# Agenda Item # 1

## SUB-003174-2024

Resubdivision of Lot 45, Mechem and Blair Subdivision

- Subdivision approval to create one (1) legal lot of record from one (1) metes-and-bounds parcel.

# DETAIL SITE PLAN

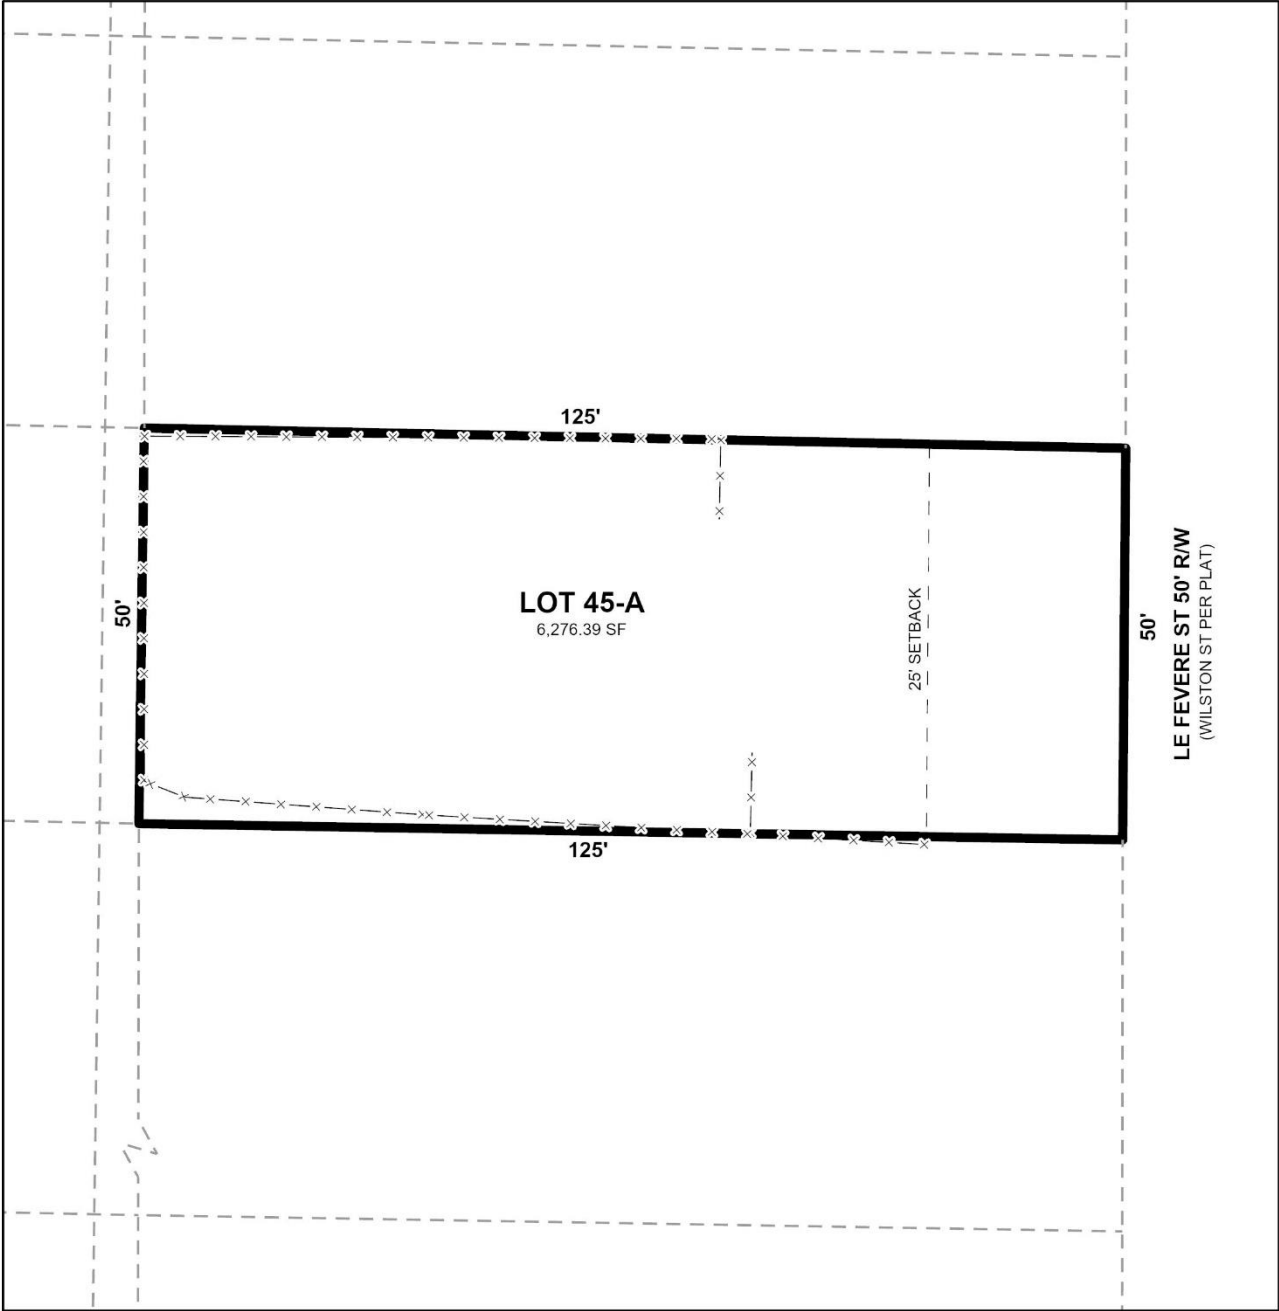
- A. Provide all of the required information on the SUBDIVISION PLAT (i.e. signature blocks, signatures, certification statements, written legal description, required notes, legend, scale, bearings and distances) that is required by the current Alabama State Board of Licensure for Professional Engineers and Land Surveyors.

- B. Check the legal reference. Provide a copy of the recorded subdivision plat referenced in the legal description.
- C. Check the date (year) listed in the NOTARY PUBLIC signature block.

- D. Add a note to the SUBDIVISION PLAT stating that as shown on the 1984 aerial photo LOT 1 will receive historical credit of existing (1984) impervious area towards stormwater detention requirement per Mobile City Code, Chapter 17, Storm Water Management and Flood Control) as follows: LOT 1 – 1,600 SF.

The site has frontage on LeFevre Street minor street with curb and gutter illustrating a compliant right-of-way width, making additional dedication unnecessary. This information should be retained on the Final Plat, if approved.

Section 6.C.2.(b) of the Subdivision Regulations requires all residential lots located within an area designated as suburban to have a minimum width of 60 feet, the preliminary plat illustrates a lot width of 50 feet. It should be noted, however, that the parcel was originally platted prior to modern subdivision standards and there are numerous lots in the area which also maintain a 50-foot lot width. As such, if approved, a waiver from Section 6.C.2.(b) of the Subdivision Regulations may be appropriate.

While the lot's size is provided in both square feet and acres on the preliminary plat, the proposed lot does not meet the 7,200 square foot minimum size requirement for lots served by public water and sanitary sewer in an R-1, Single-Family Suburban District. However, the proposed size appears to be in common with the surrounding lots that were platted alongside the subject site in 1905. As such, a waiver from Section 6.C.2.(a) of the Subdivision Regulations may be appropriate. If approved, this information should be retained on the Final Plat; or provision of a table on the Final Plat with the same information will suffice.

The preliminary plat illustrates a 25-foot front yard setback along the lots street frontage, in compliance with Section 5.C.2.(i) of the Subdivision Regulations and should be retained on the Final Plat.

1. Retention of the right-of-way width of LeFevre Street on the Final Plat, as depicted on the preliminary plat;
2. Retention of the of the lot's size in both square feet and acres, or the furnishing of a table on the Final Plat providing the same information;
3. Retention of the 25-foot front yard setback along LeFevre Street in compliance with Section 5.C.2.(i) of the Subdivision Regulations;
4. Compliance with all Engineering comments noted in this staff report;
5. Placement of a note on the Final Plat stating the Traffic Engineering comments noted in this staff report;
6. Compliance with all Urban Forestry comments noted in this staff report; and
7. Compliance with all Fire Department comments noted in this staff report.
